SUBDIVISION, PLANNED UNIT DEVELOPMENT, PLANNING APPROVAL, & SIDEWALK WAIVER STAFF REPORT Date: November 7, 2019

NAME	West Bay Academy Subdivision, Addition to
SUBDIVISION NAME	West Bay Academy Subdivision, Addition to
LOCATION	1564 & 1568 Hurtel Street and 1567, 1569, & 1577 Forrest Street (Northeast corner of Hurtel Street and Antwerp Street, extending to the Southeast corner of Forrest Street and Antwerp Street)
CITY COUNCIL DISTRICT	District 3
PRESENT ZONING	R-1, Single Family Residential District
AREA OF PROPERTY	1 Lot / 1.6± Acres
CONTEMPLATED USE	Subdivision approval to create one legal lot of record, Planned Unit Development Approval to amend a previously approved Planned Unit Development to allow multiple buildings on a single building site, Planning Approval to amend a previously approved Planning Approval to allow the operation of a church with a daycare in an R-1, Single-Family Residential District, and Sidewalk Waiver for construction of a sidewalk along Forrest Street.
TIME SCHEDULE	Not Specified.

DETAIL SITE PLAN

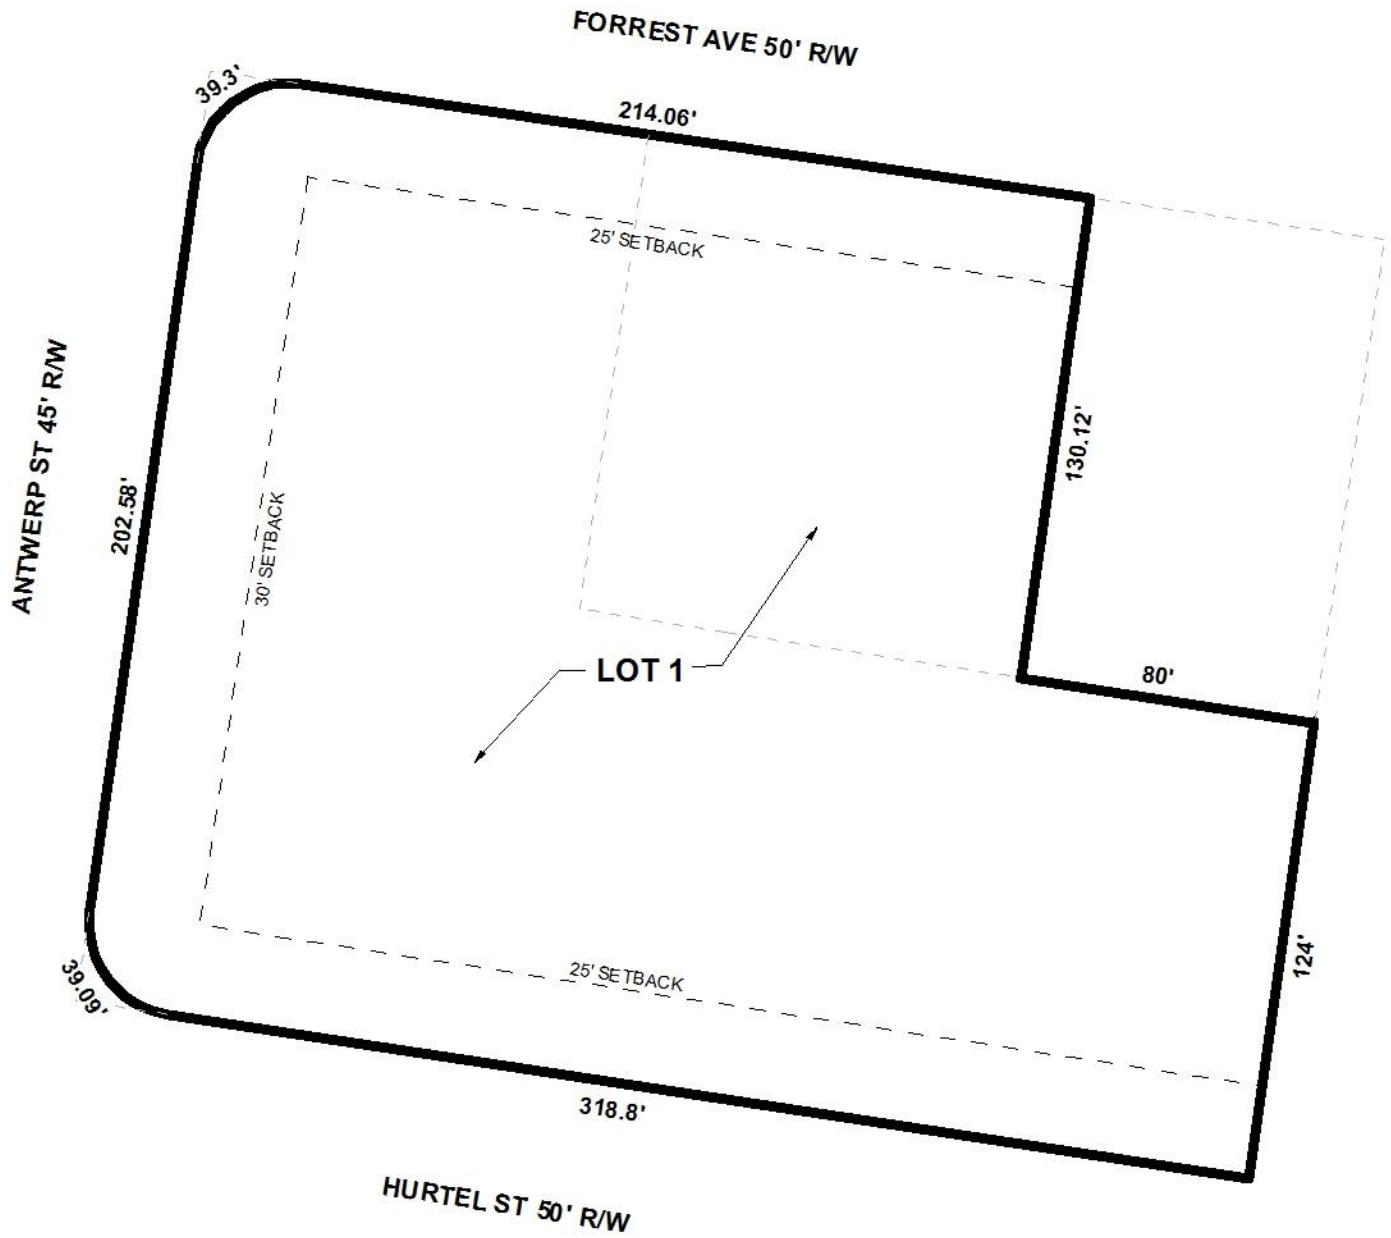
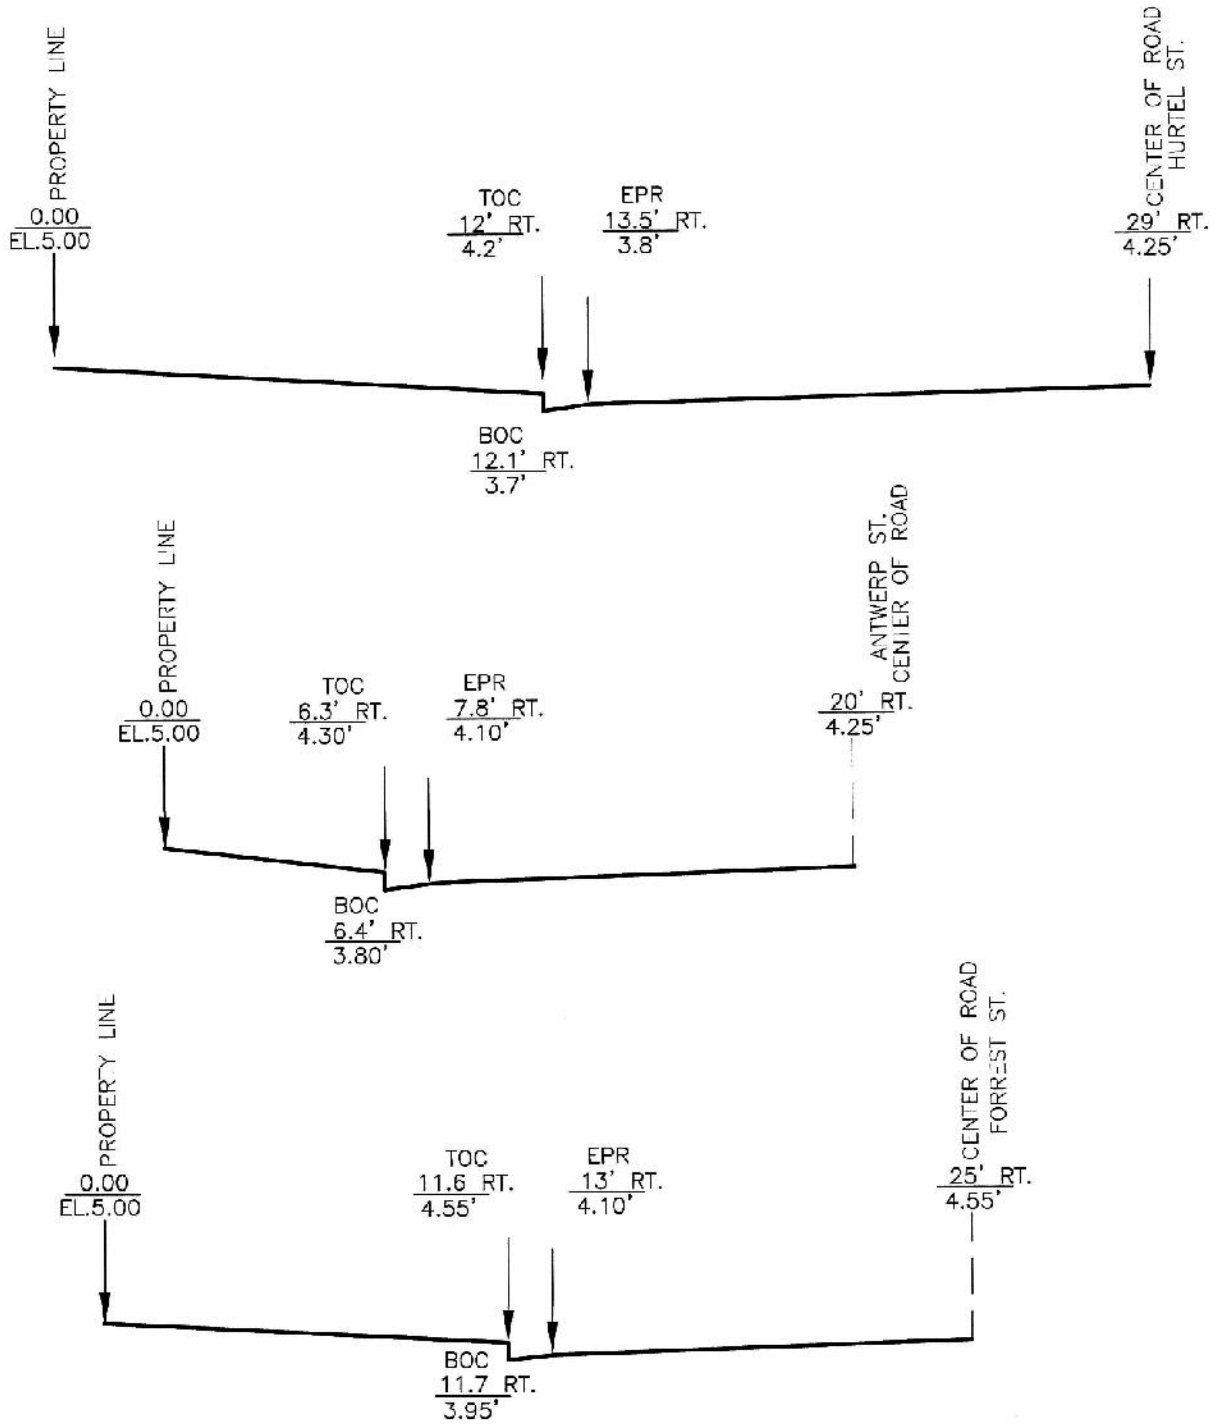
The site plan depicts the one (1) proposed lot, three (3) existing buildings, and 15 existing asphalt parking spaces and a large slab that reflects the footprint of two buildings recently removed. The site plan also indicates several existing trees, many which are large live oak trees and an existing privacy fence along a portion of the North property line where the site abuts residentially zoned and used property. To maintain a residential buffer, the fence should extend along the entire Eastern boundary where the site abuts residentially zoned and used property.

Furthermore, it appears that with the demolition (without permits) of the structure at 1564 Hurtel Street, the addition of the structure at 1577 Forrest Street, and the proposed addition of the structure at 1567 Forrest Street, that the building footprint has increased/decreased by more than

50%, thus requiring the site to come into full compliance with tree planting and landscape area requirements. No landscape area information is provided, but several existing trees are depicted on the site plan. If approved, the site should be required to come into full compliance with tree planting and landscape area requirements.

Expansion of the church/daycare use to the building at 1567 Forrest Street will likely require a range of building-related permits for the conversion from a multi-tenant dwelling. Furthermore, if this structure will be used for a daycare, site improvements may be needed for vehicle and pedestrian circulation, thus land disturbance permits may be required. Also, it appears that the building slab at 1564 Hurtel Street is being used for parking and a dumpster – all without use approvals or permits.

1) Revision of the site plan to depict parking that is being utilized on the building slab of 1564 Hurtel Street;
2) Revision of the site plan to depict any existing and/or proposed improvements around the proposed new daycare structure;
3) Revision of the site plan to illustrate any and all dumpsters on the site; and
4) Revision of the site plan to demonstrate that the development will fully comply with tree planting and landscape area requirements.

1) Revision of the site plan to depict parking that is being utilized on the building slab of 1564 Hurtel Street;
2) Revision of the site plan to depict any existing and/or proposed improvements around the proposed new daycare structure;
3) Revision of the site plan to illustrate any and all dumpsters on the site; and
4) Revision of the site plan to demonstrate that the development will fully comply with tree planting and landscape area requirements.

1) Revision of the site plan to depict parking that is being utilized on the building slab of 1564 Hurtel Street;
2) Revision of the site plan to depict any existing and/or proposed improvements around the proposed new daycare structure;
3) Revision of the site plan to illustrate any and all dumpsters on the site; and
4) Revision of the site plan to demonstrate that the development will fully comply with tree planting and landscape area requirements.
